MISSION REPORT / RAPPORT DE MISSION

**Vat Phou and Associated Ancient Settlements within the Champasak Cultural Landscape (N481)/Vat Phou et les anciens établissements associés du paysage culturel de Champassak (République démocratique populaire lao) (N 481)
15-21 February 2012/15-21 février 2012**

Report on the Joint World Heritage Centre/ICOMOS/ICCROM Reactive Monitoring Mission to Vat Phou and Associated Ancient Settlements within the Champasak Cultural Landscape (Lao People's Democratic republic)

14A under construction (above) and as constructed (below)

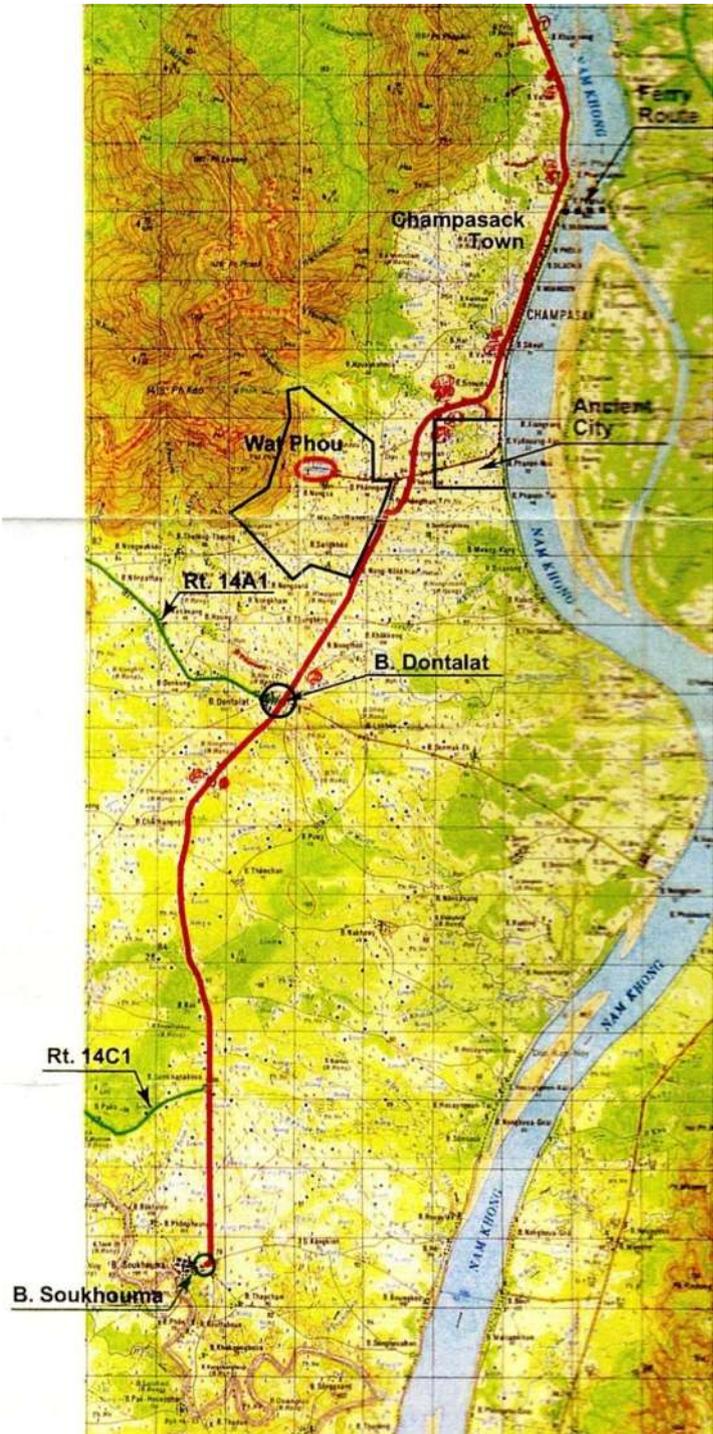
Surprisingly enough, the visual impact of the road (throughout all four zones), is less than the mission experts expected. In fact, from the various platforms of Vat Phou, the road is hard to detect in the landscape. Of course, while on the road – or near the road, its presence is obvious, although the greening of the verges will soften its visual impact. And, in regard to the natural greening at the sides of the road, the mission experts question the planting of roadside trees. Although aesthetically pleasing to many, this approach could well draw more attention to the road, especially from the temple platforms. It is also a question of place-specific appropriateness for this particular kind of roadside treatment.

(3) In regard to the visual impact of Route 14A, it would seem best to refrain from planting a linear screen of trees on either side of the road as this would serve to emphasize the dramatic cut of the road through the cultural landscape – and would be especially visible from the platforms of Vat Phou.

Annexe 8: Proposed Landscape Plan

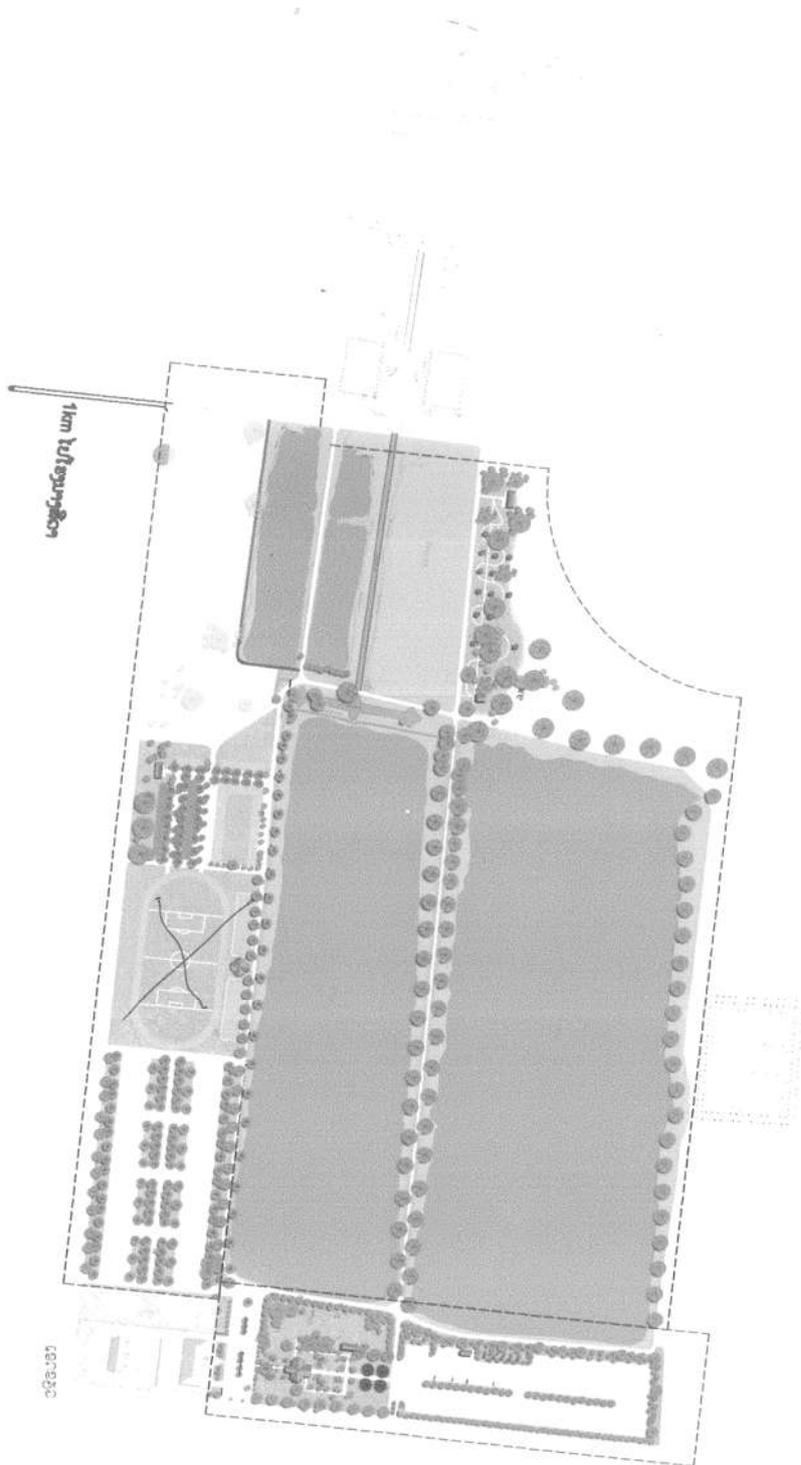
(4) In the longer term as well, there must be a comprehensive landscape plan for Vat Phou - Zone 4 (Monument Management Zone). The current plan, apparently now cancelled, reflects a lack of understanding of the values of the site and the use of inappropriate models. Areas of concern include street lighting fixtures, paving materials, tree planting patterns, etc. As (3), there should be no piecemeal decision-making. Every effort should be made to have a comprehensive plan, which must be approved before implementation by the World Heritage Centre. (See Annexe 8 for the most recent landscape plan, which appears to have been cancelled.)
